CITY PLAN COMMISSION

THURSDAY, OCTOBER 9, 2025

RECORD NO.: Plat-25-000095 (S245-241) SENIOR PLANNER: Sharmila Shrestha

REQUEST: An application to replat a 6.8166-acre tract of land containing City Blocks 1/409 and 2/409 and a portion of an abandoned Dragon Street to create one lot on property located between Wichita Street and Continental Avenue, southwest of Slocum Street.

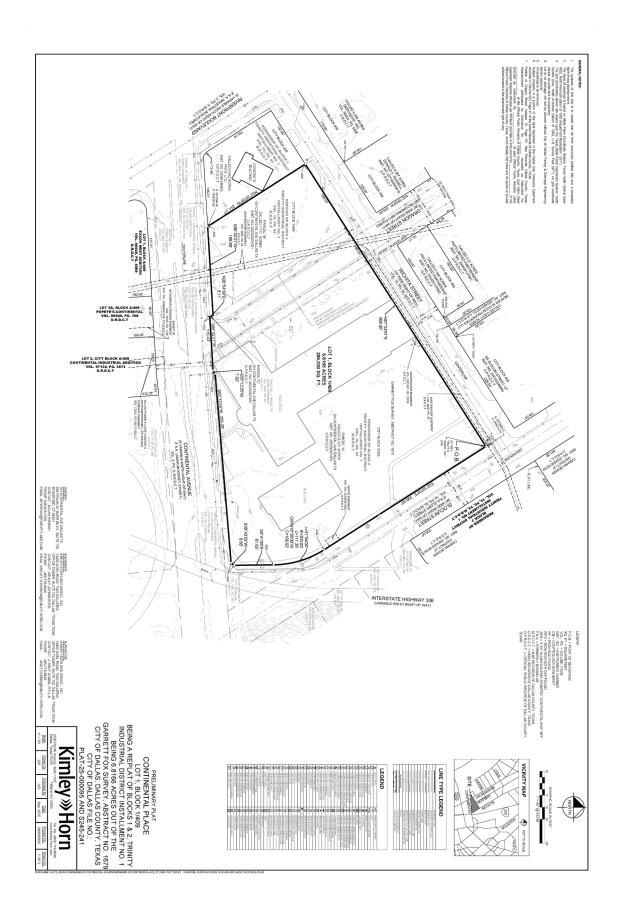
15. On the final plat, dedicate 67 feet of right-of-way (via fee simple) from the established center line of Continental Avenue. Section 51A-8.602(c); Section 51A-8.604(c)

- 16. On the final plat, dedicate a minimum of 5-foot by 5-foot corner clip (via fee simple or street easement) at Slocum Street and Wichita Street. Section 51A-8.602(d)(1)
- 17. A larger corner clip may be requested during engineering plan and traffic review to accommodate an adequate turning radius, or to maintain public/traffic appurtenances, within the area of the corner clip. 51A 8.602(d)(1), 51A 8.608(a).
- 18. Must coordinate with Transportation Department for any traffic signal requirements that are deemed necessary for improving pedestrian accessibility and safety related to site development (Contact Srinivasa Veeramallu with Traffic Signals). 51A-8.606, 51A-8.608.

- 24. Additional design information needed to complete review. Provide a brief description of the proposed project and a copy of the site plan to daniel.silva1@dallas.gov to determine street lighting requirements.
- 25. A tree survey is required to be submitted and approved by the Arborist. The tree survey must include all trees in the site or adjacent right-of-way 8-inch in diameter or larger.
- 26. On the final plat, show the abandonment of Dragon Street on the plat as follows: Abandonment authorized by Ordinance No. ______, recorded as Inst. Nos.

(Cert.	ORD No.	,	QCD	No).	Utility
Fasen	nents retaine	d

- 27. On the final plat, change "Interstate Highway 35E" to "Stemmons Freeway/ Interstate Highway No. 35E (AKA U.S. Highway No. 77)"
- 28. On the final plat, identify the property as Lot 1 in City Block 1/409.
